Re: ZC Case 19-10/ Valor Development, LLC/ Square 1499
Hearing Date: October 7, 2019

Response of Citizens for Responsible Development to Comprehensive Transportation Review Zoning Case 19-10 Valor Development LLC

SUBJECT: ZC Case No. 19-10, The Lady Bird

Existing conditions in N/S alley

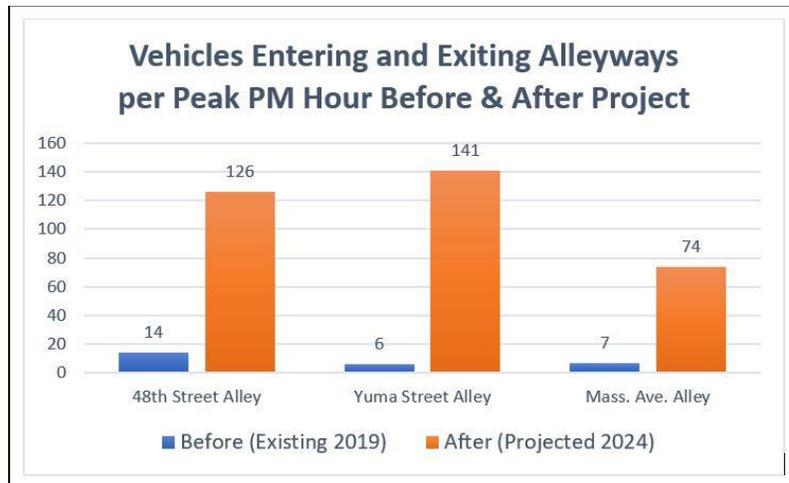
The width of both the E/W alley and the N/S alley will be 20 feet. While the Applicant claims that the N/S alley will be widened, in fact this alley will be moved to allow 12 feet of space for trash receptacles. After construction, this alley will be 20 feet wide. Currently, the width of the N/S alley extends up to 50 feet in certain sections.

Proposed changes to N/S alley with Valor building in red
D. Barnes
